TO: Expert Panel considering Taharoa Ironsands Limited's substantive Fast-track application for the Central and Southern Blocks Mining Project

WWLA1303

Taharoa Ironsand Fast Track Application – Response to Hydrogeology Related Comments from Invited Parties

Figure 1. Updated groundwater monitoring data. Lines represent continuous monitoring data and dots represent manual water level measurements taken to confirm data.

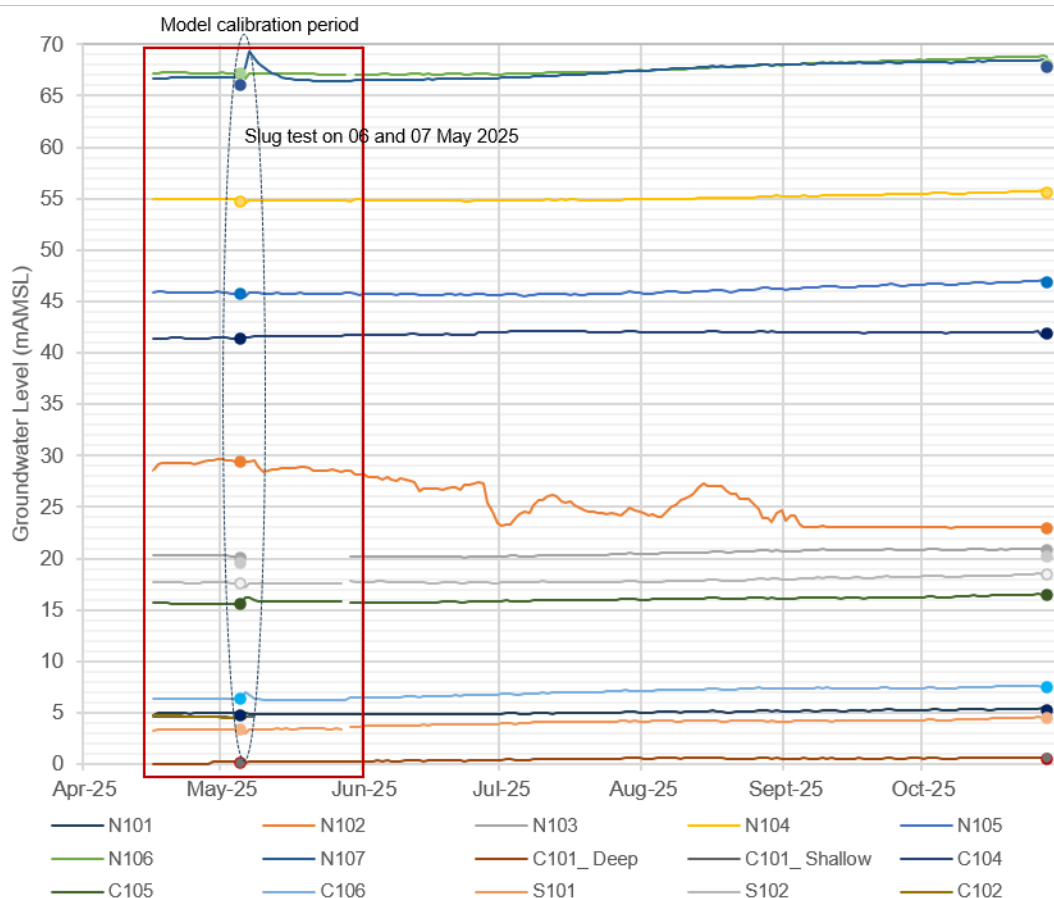
WWLA acknowledges the limitations of a 44-day data set used for groundwater model calibration. This data was only available following an intensive effort to install a network of monitoring piezometers across the Northern, Central, and Southern Blocks of the Mine.

Data collection at the 18 monitoring piezometers is ongoing, having been updated most recently on 31 October 2025 which extended the data set to 195 days for most sites² (**Figure 1**). The monitoring data generally shows that the water levels are stable, with a steady rise during the winter of 2025 that is consistent with typical seasonal variation anticipated in groundwater levels. The exception is the N102 piezometer, located in the TIL Northern Block, approximately 600 m north of the Mitiwai Stream, for which the measured water levels fluctuated for approximately five months before levelling off and becoming consistent with the other monitoring locations. The cause of this fluctuation is currently unresolved but thought to be related to an initial high groundwater table following construction of the piezometer.

On the whole, the data gathered from the further groundwater monitoring undertaken since the 44-day collection period demonstrates that the data used in model calibration is broadly representative of groundwater conditions at the site over time.

Figure 2. Simulated groundwater discharge from aquifer into ocean and ocean into aquifer for mining and non-mining scenarios.

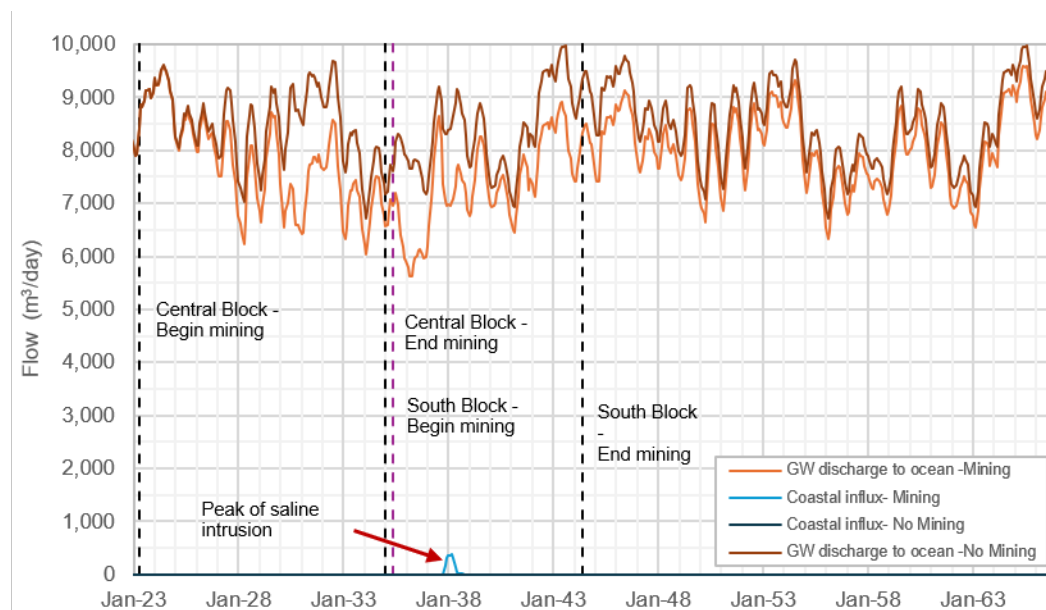
Upon further consideration of the review comments, it was determined that saline intrusion does not occur at the time of deepest excavation, but rather at the time when the excavation is closest to the ocean. This corresponds to Extension 2 excavation area of the Southern Block, shown in Figure 11 of the Hydrogeology Assessment.

The inland influx of seawater (saline intrusion) that was simulated is highlighted with a red arrow in **Figure 2**¹⁰. The figure shows that saline intrusion is modelled to occur for a brief time (13 months) during mining of the Southern Block and not at all during mining of the Central Block. The volume during this 13-month period ranges from 2 m³/day to a maximum of 372 m³/day (average during this period is 161 m³/day), which is a small fraction of the 7,018 m³/day of groundwater that is simulated to discharge offshore as part of the regional groundwater flow within the model domain at the same time.

Because saline intrusion in this mining scenario is a transient phenomenon that occurs strictly while the excavation is open near the coastline, it is governed primarily by the steep, mechanically imposed hydraulic gradient between the ocean and the pit. While this engineered gradient is the dominant control, climatic factors (such as seasonal precipitation and recharge) will play a secondary role by either modulating local groundwater mounding, which can provide a minor buffer, or slightly compounding the intrusion during extended dry periods.

Figure 4. Simulated groundwater discharge into the mine pits, highlighting time of maximum saline intrusion.

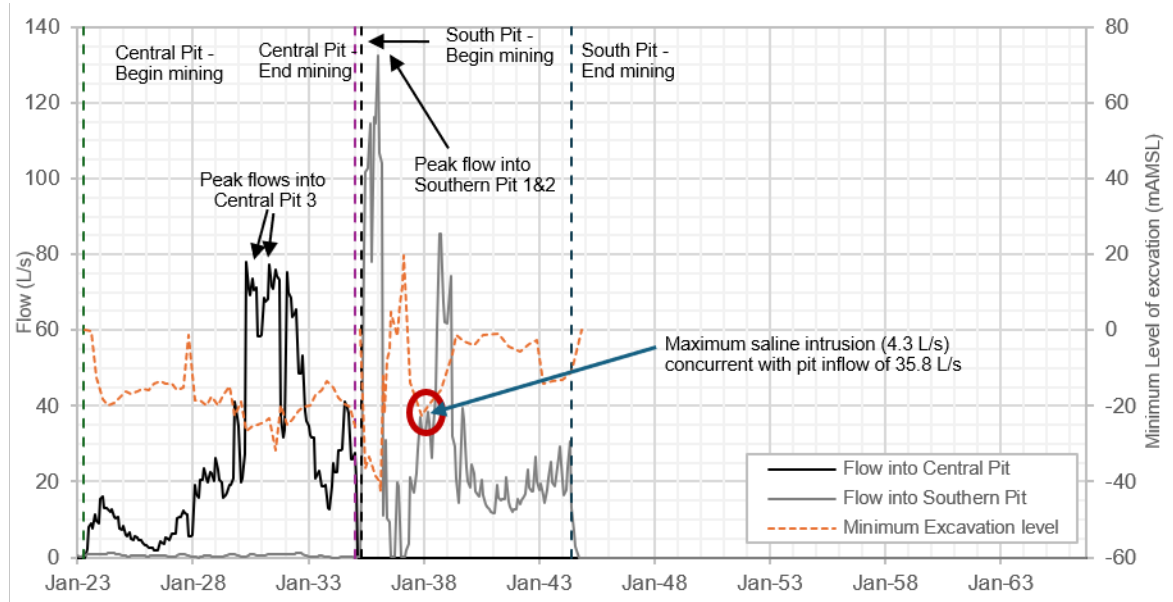
WRC (Memo from Sung Soo Koh – Hydrology, section 3.5) requests a water balance of groundwater discharge into the mine pit to be used to assess the maximum salinity of the slurry extracted from the pit. The maximum discharge of saline water into the pit is 372 m³/day (4.3 L/s), as explained in **Section 3.4.1**. The simulated groundwater discharge into the South Pit - Extension 2 (the active mining area at this time) is 3,084 m³/day (35.7 L/s) as shown in **Figure 5** (a reproduction of Figure 29 from the Hydrogeology Assessment modified to highlight the time of maximum saline intrusion). Conservatively assuming that all sea water influx emerges in the pit and assuming there is no surface runoff at the time, it would amount to 12% of the groundwater inflow to the pit being sea water.

The electrical conductivity of the sea water is approximately 42,950 uS/cm and the fresh water is 200 uS/cm¹¹, so the conductivity of the mixture would be approximately 5,356 uS/cm (i.e. brackish). As previously mentioned, in Conditions 2 and 3 of the AUTH142035.14.01 and Condition 7 of AUTH142035.16.01, TIL has committed to discharging process water in a manner that will not impact any freshwater body.

Figure 5. EC monitoring in deep aquifer piezometers (refer to Figure 3 for locations).

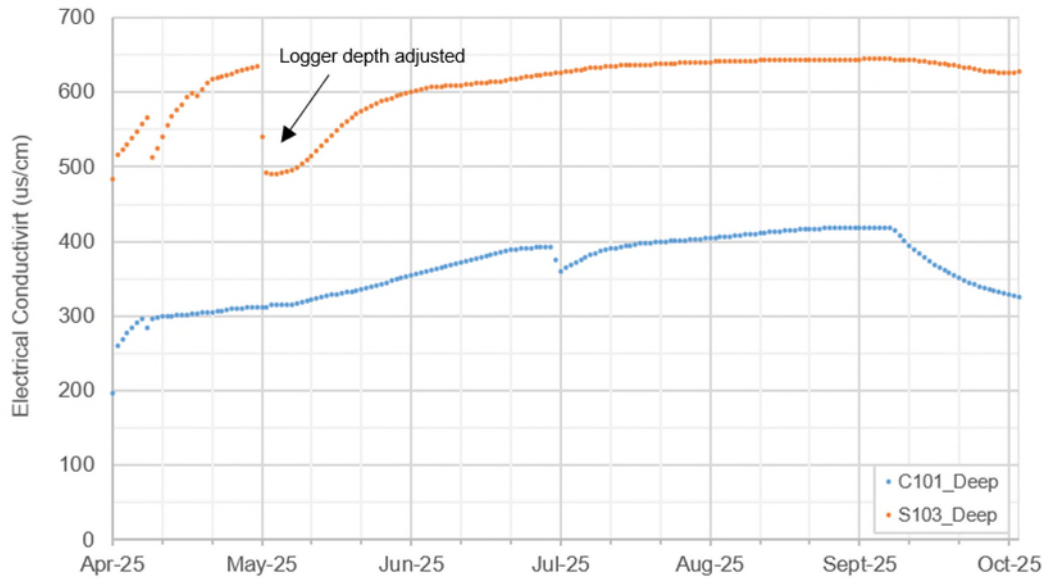
The WRC and DOC comments both mention a lack of saline intrusion monitoring under the proffered consent conditions, although there have been no issues with saline intrusion through the mining that has already occurred at the site over the past 50+ years.

Electrical conductivity ("EC") monitoring is ongoing at piezometers C101, S103, and Wetland 80. These locations respectively represent an area that was deemed to be potentially vulnerable to saline intrusion in the deep aquifer during mining (C101), and areas within or adjacent to groundwater connected wetlands. As previously mentioned, saline intrusion is only a risk below sea level, though some salinity can reach open water bodies via aerosol deposition (sea-spray) which occurs naturally in the windy coastal environment.

All monitoring data has indicated that the deep aquifer is not saline and is hydraulically separate from all freshwater features. Monitoring data from the deep aquifer that has been collected to date is shown in **Figure 5**, indicating freshwater conditions in the aquifer at both locations.
